**CPUC Staff Comments on CAISO's Draft DR and EE Roadmap****General Comments**

The California Public Utilities Commission (CPUC) staff appreciates the opportunity to provide comments on CAISO's draft DR and EE Roadmap, dated June 12, 2013. The roadmap provides a viable plan for future Demand Response resources and lays out concrete, specific actions that will take these resources to a new level of usefulness. The CPUC staff agrees with the CAISO that DR has potentially great value as: 1) a flexible capacity resource for the renewable integration, 2) a balancing energy and ancillary service resource, 3) an alternative to transmission upgrades. We share the CAISO's concerns about the challenges with the current utilities' DR programs from resource planning, grid operation, and customer perspectives. The four paths laid out in the CAISO's draft roadmap provide a clear mechanism to allow the CAISO and the CPUC to address the supply-side and demand-side DR/EE issues effectively.

### Figure 1: RA Counting for DR (Prior to 2013)

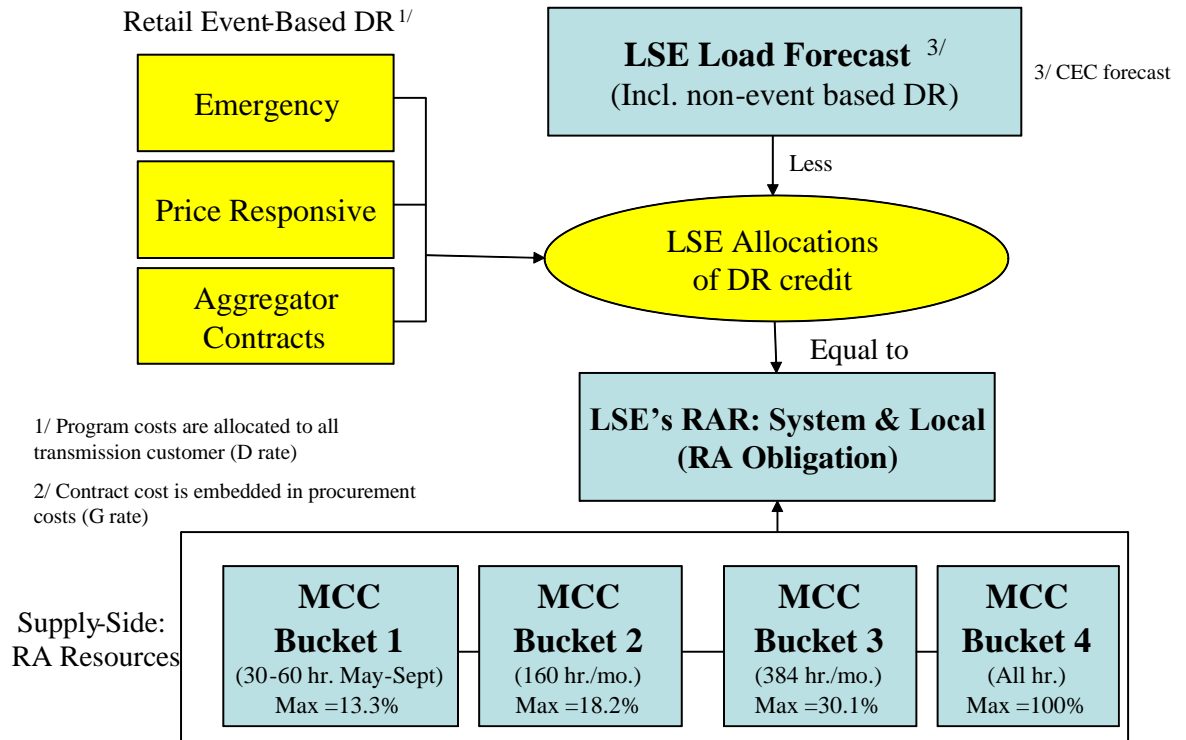
- DR as Resource Adequacy (RA) – Current and Past Practices: CAISO’s characterization of how DR is counted for Resource Adequacy is no longer in practice.<sup>1</sup> Prior to 2013 DR resources were accounted for by deducting the expected DR capacity from the RA requirement (see Attachment B, Figure 1). Since 2013 DR resources are counted as supply-side resources in RA filings (see Attachment B, Figure 2). In the 2012 RA decision,<sup>2</sup> the CPUC adopted a DR Maximum Cumulative Capacity (MCC) bucket for DR resources so that DR could be accounted for as a resource on the supply-side (similar to a physical resource). Energy Division (ED) staff implemented the DR MCC bucket into the 2013 RA filing template. Under this mechanism, DR programs with load modifier operational characteristics are also accounted for as resources.
